Technical Service Information

FORD AODE/4R70W NEW DESIGN FOR ALL MODELS MECHANICAL DIODE INTERMEDIATE SPRAG

Figure 1

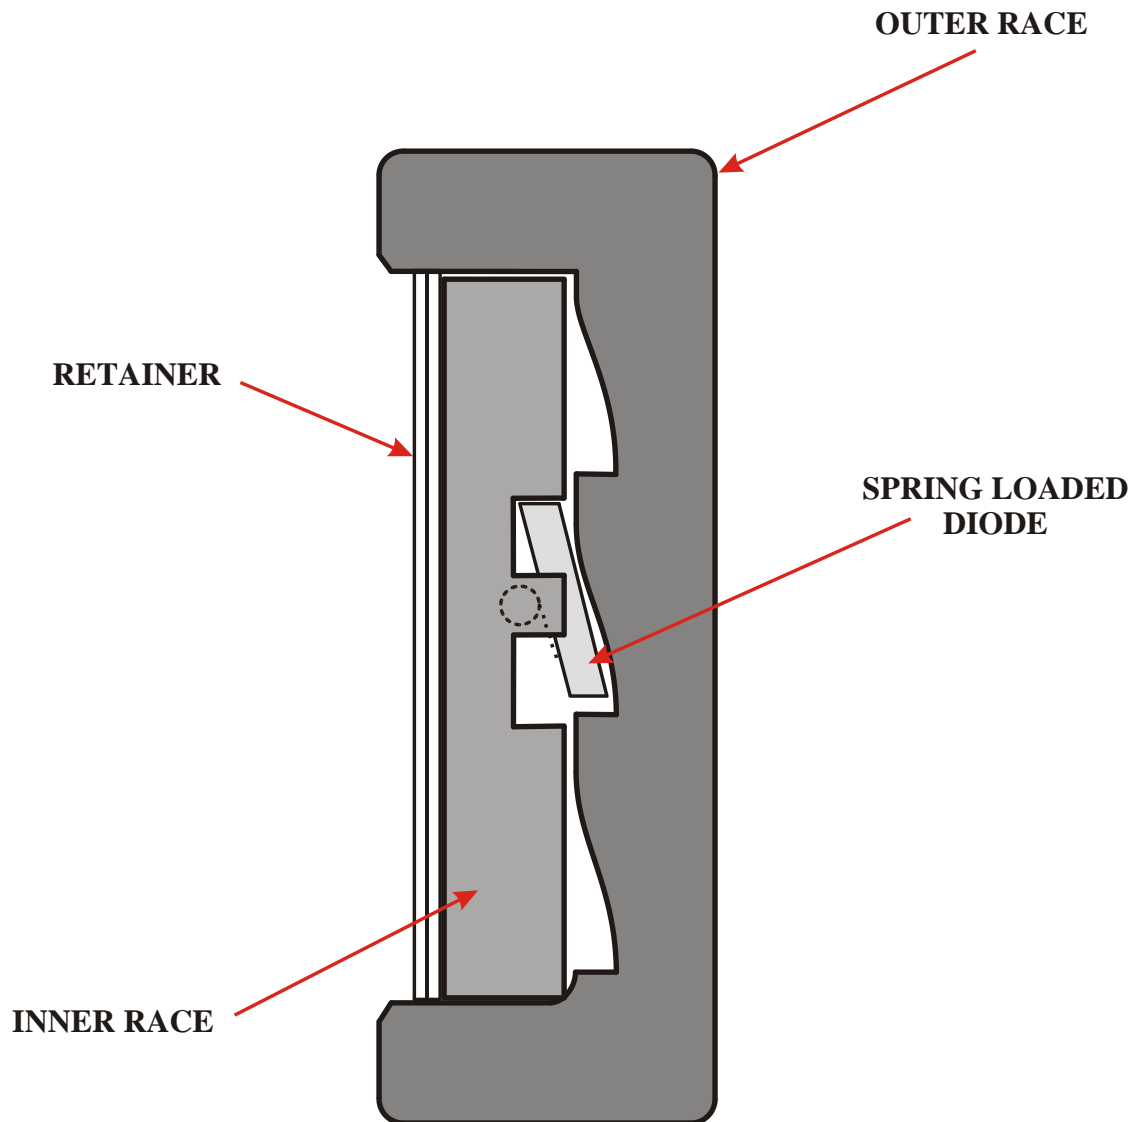
CHANGE: There is now available from Ford Motor Company, a ***Mechanical Diode*** sprag assembly to replace the previous design Intermediate Roller Clutch. It also requires replacing the Reverse Input Housing to accommodate the new design mechanical diode sprag assembly.

This new design can be manufactured in any configuration of outer race, inner race and retainer to hold the parts together, but all will have several spring loaded "Diodes" inside to do the holding and freewheeling. Refer to Figure 1 for a basic cross section of how a mechanical diode sprag assembly works.

Figure 2

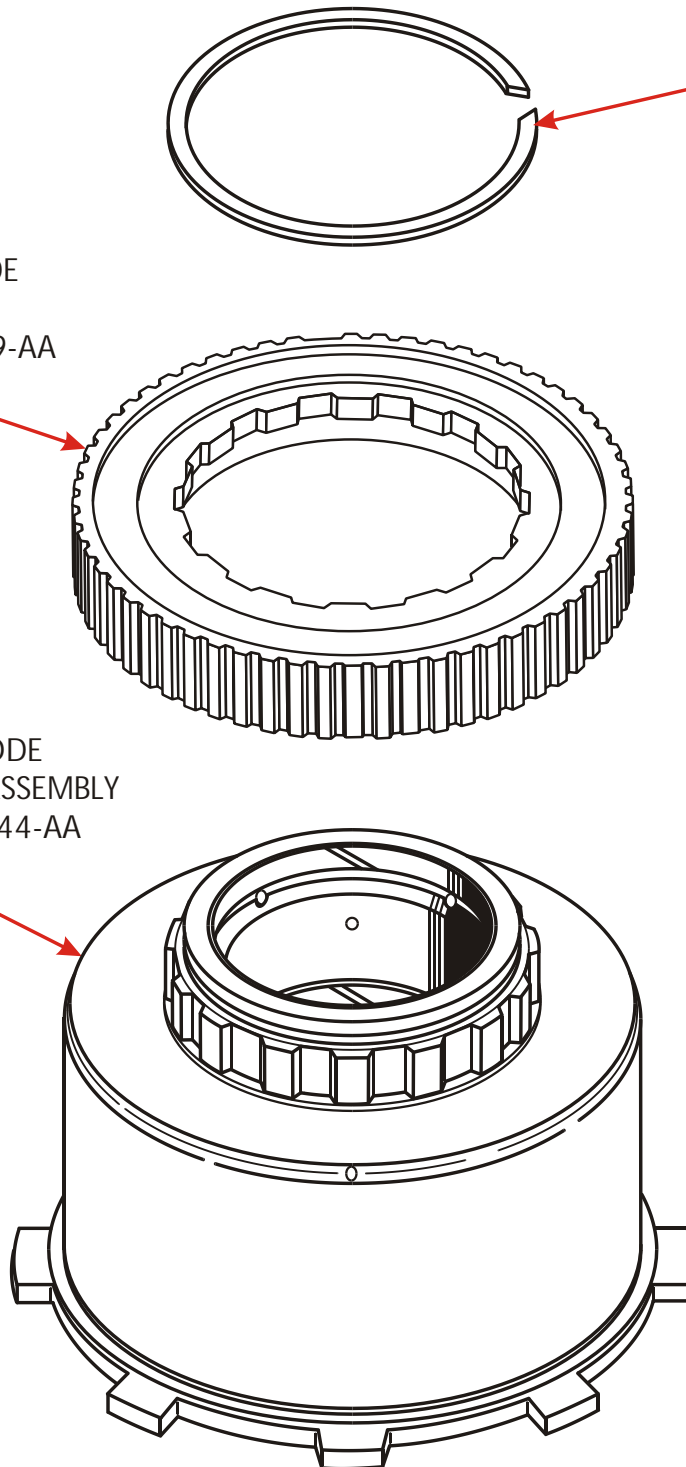
- (1) MECHANICAL DIODE SPRAG ASSEMBLY - Totally new design to replace the previous design intermediate roller clutch in AODE and 4R70W transmissions (See Figures 1 and 2).
- (2) REVERSE INPUT HOUSING - New design housing with "Splines" in place of the previous inner race, to accommodate the new design mechanical diode sprag assembly. Refer to Figures 1 and 2.
- (3) RETAINING RING - No dimensional changes on the snap ring, you still use the original snap ring. When installed, the mechanical diode assembly may move back and forth approximately .010" and this is normal (See Figure 2).

Mechanical Diode Sprag Assembly	F8AZ-7A089-AA
Reverse Input Housing Assembly (Mech Diode)	F8AZ-7D044-AA
Retaining Ring	391267-S
